SAFETY EVALUATION
FOR REVISING THE SPECIFICATION FOR
UPRATE
VIRGIL C. SUMMER NUCLEAR STATION
TECHNICAL SPECIFICATIONS

Description of Amendment Request

South Carolina Electric & Gas Company (SCE&G) proposes to revise the following Virgil C. Summer Nuclear Station (VCSNS) Technical Specifications (TS) pages: 1-5, 3/4 4-31, 3/4 4-32, 3/4.11-5, and 6-16a. These changes support the Uprate project and provide the following:

Figure 3.4-2 V. C. Summer Unit 1 Reactor Coolant System Heatup Limitations (Heatup rates up to 50 and 100°F/hr) Applicable for the First 14 EFPY (With Margins 10°F and 60 psig For Instrumentation Errors)

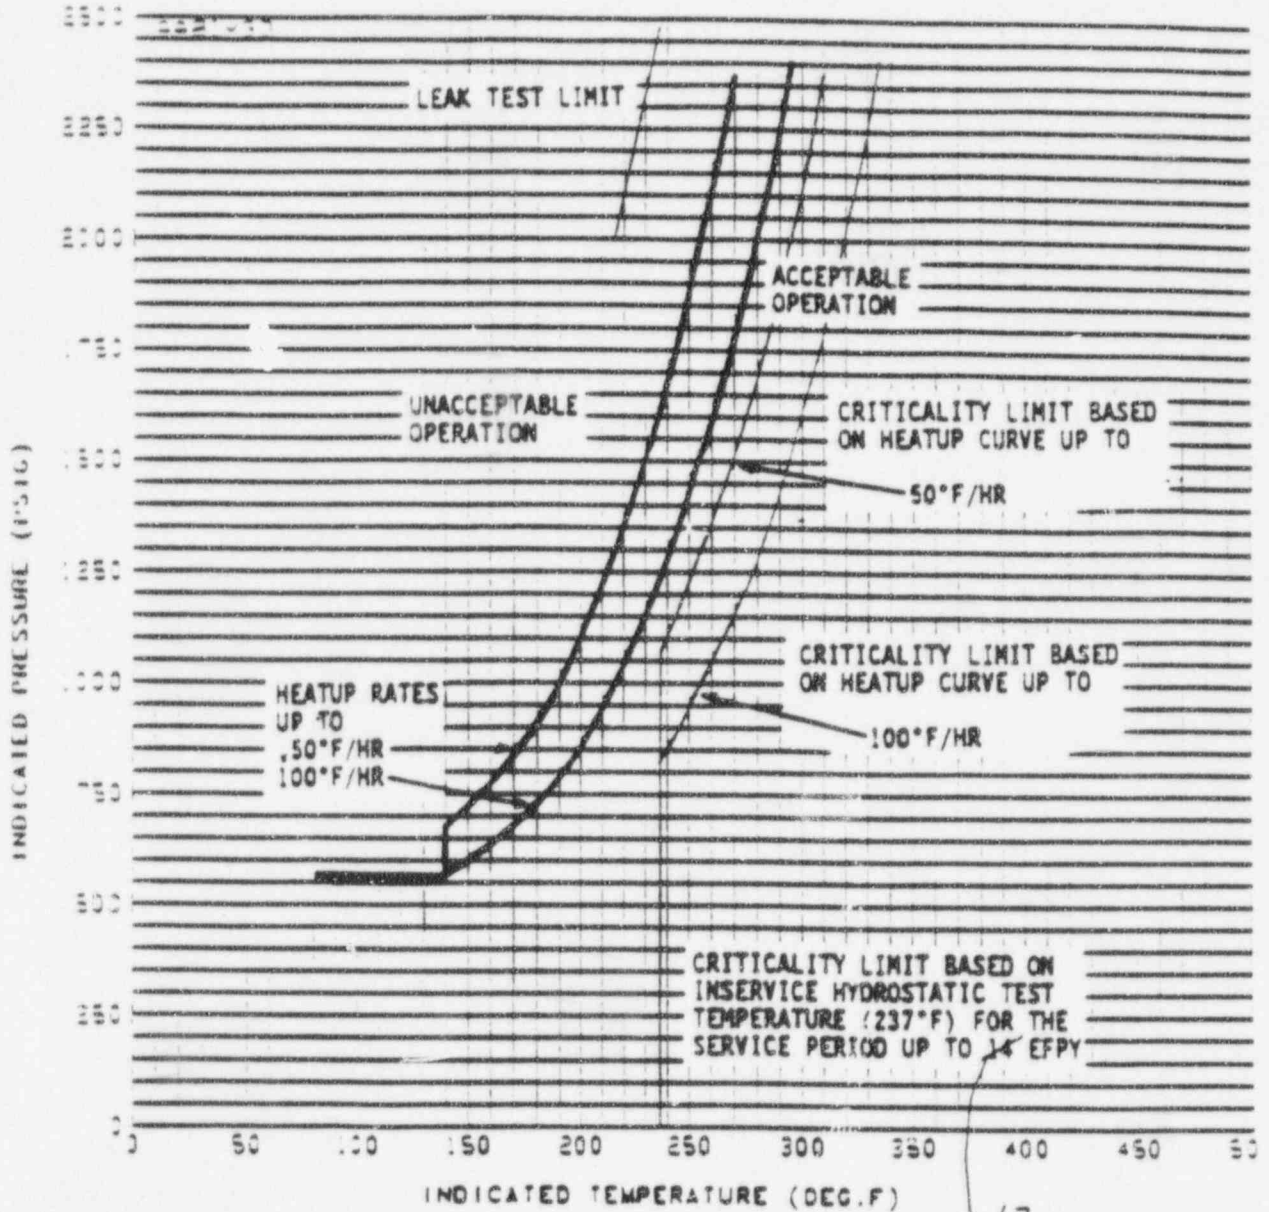
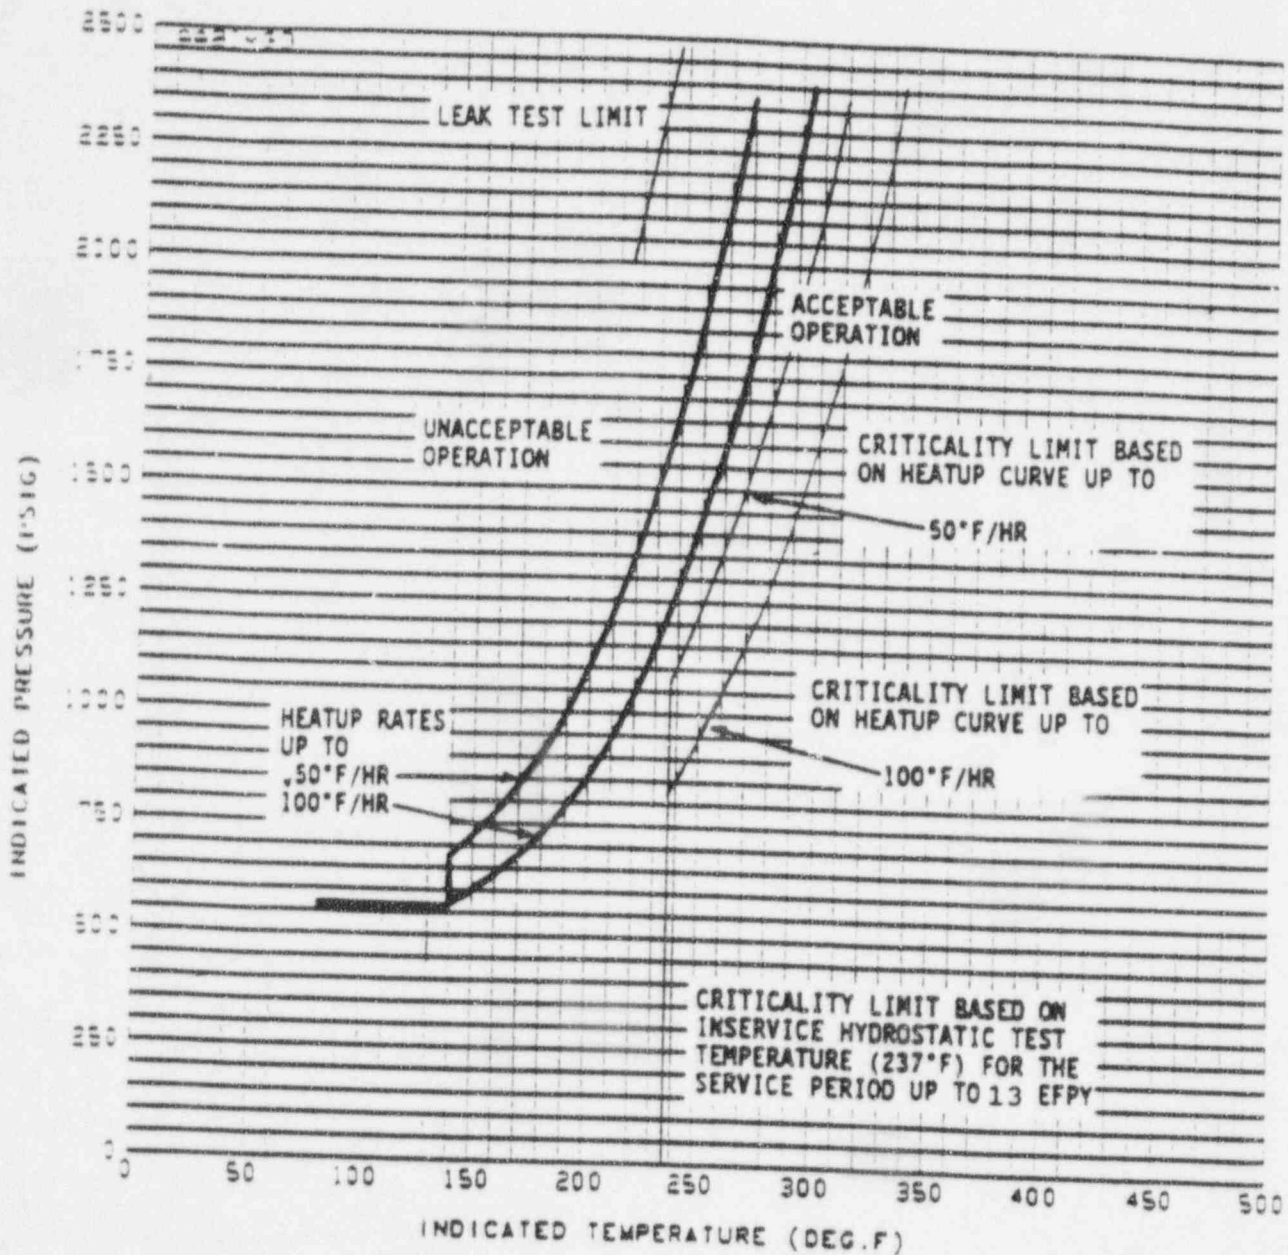
Increased neutron fluence resulting from uprate core conditions has an effect on the reactor vessel Pressure Temperature Curves. Their applicability will change from 14 Effective Full Power Years (EFPY) to 13 EFPY with no other changes at this time.

The Pressure Temperature Limitations Curves are derived using NRC Approved Methodology to comply with 10 CFR 50, Appendix G. These curves provide an acceptable range of operating temperatures and pressures for heatup, cooldown, low temperature overpressure, criticality, and inservice leak and hydrostatic testing conditions. The reduction in applicability for these curves has no effect on the curves themselves. Only the amount of time between the next scheduled specimen capsule analysis and the next revision to these curves will be effected.

Figure 3.4-2V. C. Summer Unit 1 Reactor Coolant System Heatup Limitations (Heat up rates up to 50 and 100°F/hr) Applicable for the First 13 EFPY (With Margins 10°F and 60 psig For Instrumentation Errors)

Figure 3.4-3 V. C. Summer Unit 1 Reactor Coolant System Cooldown (Cooldown rates up to 100°F/hr) Limitations Applicable for the First (13) $\frac{1}{4}$ EFPY (With Margins 10°F and 60 psig For Instrumentation Errors)

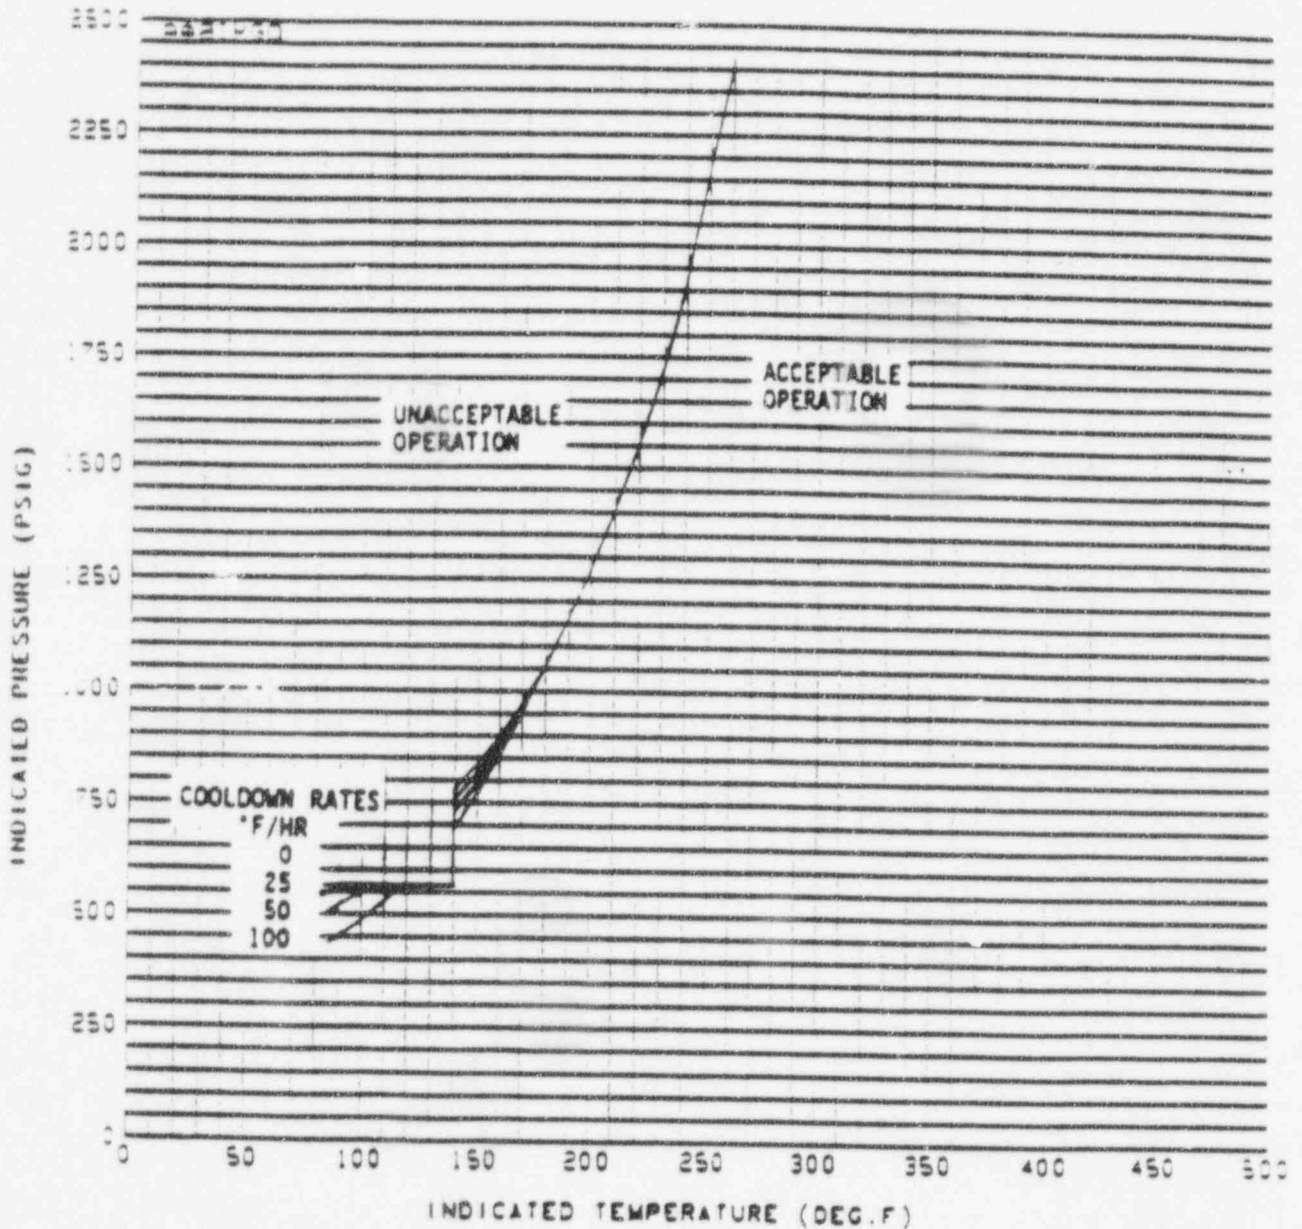
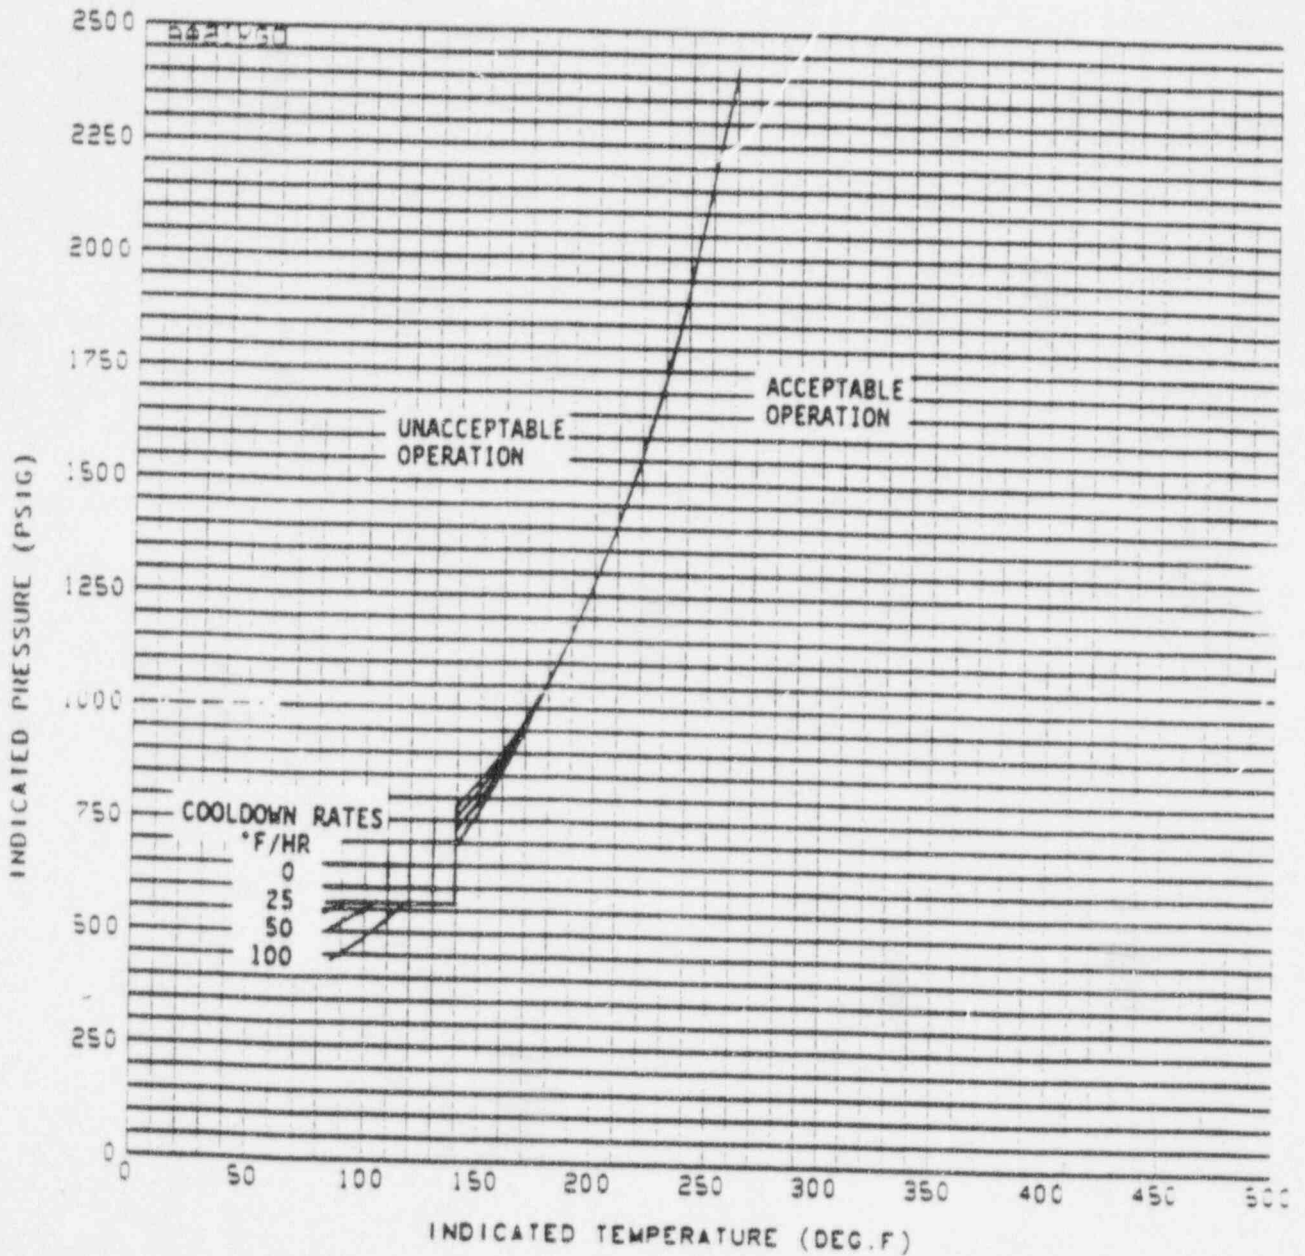
The revision to the Pressure Temperature Limits will not adversely impact the RCS Pressure Boundary. The length of time these curves will be applicable, due to increased neutron fluence, is being reduced. Before the 13 Effective Full Power Years have elapsed, new curves will be generated to reflect the analysis of the specimen capsule and will be derived utilizing NRC approved methodology.

Figure 3.4-3 V. C. Summer Unit 1 Reactor Coolant System Cooldown (Cooldown rates up to 100°F/hr) Limitations Applicable for the First 13 EFPY (With Margins 10°F and 60 psig For Instrumentation Errors)
